Access Compliance Report Public Rights-of-Way (Curb Ramps)

Main Street: BENJAMIN_DR Cross Street: SIENNA_PKWY Location: NE

ADA ID: RPRK211020170941 Ramp Type: Type 1 - Perpendicular Initial Pass/Fail: Fail Overall Compliance: No Severity Score: 2

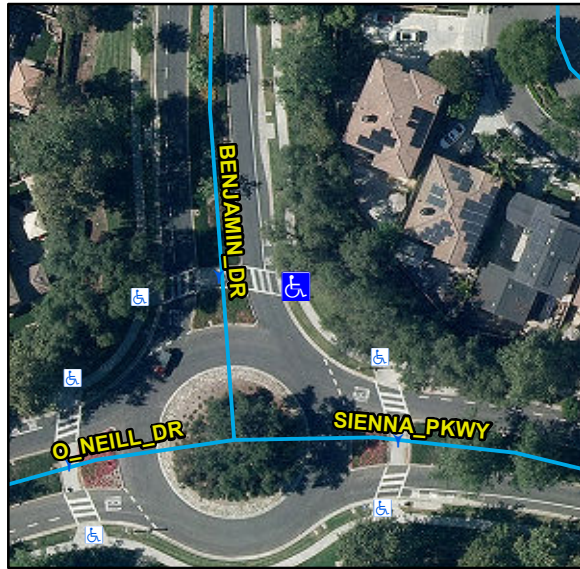
R304.2.2, R304.5.3, STD 1115

Compliance	Description	Data	Compliance	Description	Data
N/A	Ramp Length (in)	125	N/A	Flare Type LT	
Yes	Ramp Width (in)	60			N/A
Yes	Ramp Run Slope (%)	7.3	N/A	Flare Slope LT (%)	N/A
No	Ramp Cross Slope (%)	2.4	N/A	Flare Traversable LT	N/A
N/A	Landing Present	N/A	N/A	Flare Type RT	
N/A	Landing Length (in)	N/A			N/A
N/A	Landing Width (in)	N/A	N/A	Flare Slope RT (%)	N/A
N/A	Landing Run Slope (%)	N/A	N/A	Flare Traversable RT	N/A
N/A	Landing Cross Slope (%)	N/A	N/A	DWS Provided	N/A
N/A	Landing Movement Obstructed?	N/A	N/A	DWS Contrast	N/A
	Landing Movement Type	N/A	N/A	DWS Length (in)	N/A
N/A	Landing Shared	N/A	N/A	DWS Full Width	N/A
N/A	Clear Space	N/A	N/A	DWS Offset Left (in)	N/A
N/A	Clear Space To Crosswalk (in)	N/A	N/A	DWS Offset Right (in)	N/A
N/A	Marked Crosswalk 1	Yes	N/A	Marked Crosswalk 2	N/A
	Crossing 1 Direction	W		Crossing 2 Direction	N/A
	Marked Crosswalk 1 Width (in)	1		Marked Crosswalk 2 Width (in)	N/A

Remove & Replace Entire Ramp.
